**Subject line:** NPD Closure Project

**CEAA Reference number:** 80121

**Initial Independent Review of Hydrogeological Issues  
Pertaining to the Draft Environmental Impact Statement (EIS)  
for the Proposed Decommissioning of the  
Rolphton Nuclear Power Demonstration (NPD) Reactor**

Figure 1 - NPD Excavations into Precambrian Bedrock

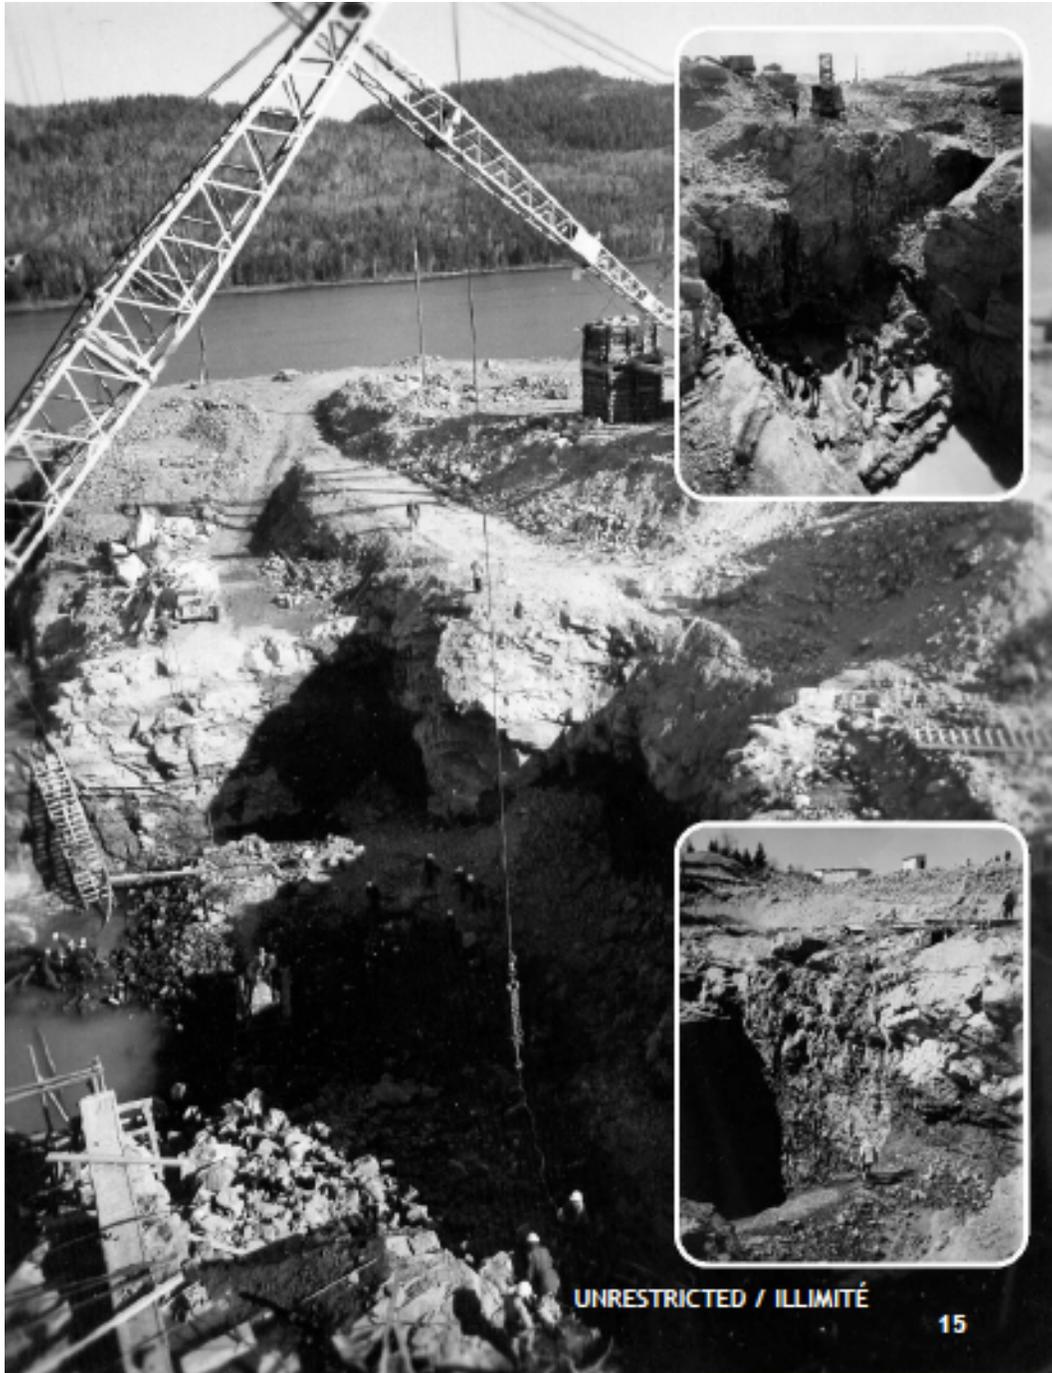
As described earlier the NPD Reactor was constructed in an excavation which went deep into the tough Precambrian bedrock. The bedrock surface around the reactor is about 122 meters above sea level (masl), and the depth of excavation for the lowest part of the structure (in the area of the Waste Area Sump) is below 104 masl - so the excavation is about 18 meters into the bedrock. Images taken at the time of construction show impressively deep excavations on the NPD site (please see **Figure 1** and **Figure 2** at the end of this review).

As discussed previously, the site investigations which provide the foundation for the hydrogeological impact assessment in the Draft EIS did a poor job of characterizing the bedrock hydrogeology. Hydraulic conductivity in the bedrock was measured at only one location - the BH16-02 well nest - and the hydraulic conductivities found there were assumed to be identically applicable across the entire site study area.

In particular, the assumed low bedrock hydraulic conductivity used in the computer model forces the vast majority of groundwater flow from the NPD site upward and out of the bedrock, and into the sandy overburden fill (in the channels which were excavated into the top of the bedrock for the tile drains and the pipes for reactor cooling water). This sandy fill would provide much more attenuation (ie. "filtration" and dilution by a variety of physical and chemical processes) than would be the case if the groundwater were moving through fractures in the disturbed bedrock beneath the sandy fill.

Once the field work has been completed, the data obtained should be used to update the computer modelling (currently presented in the 2017 Updated Groundwater Modelling Report and the 2017 Resaturation Modelling Report), and the updated model data can then be used to revisit and revise the effects assessments for Valued Components (VCs) in the aquatic and terrestrial ecosystems.
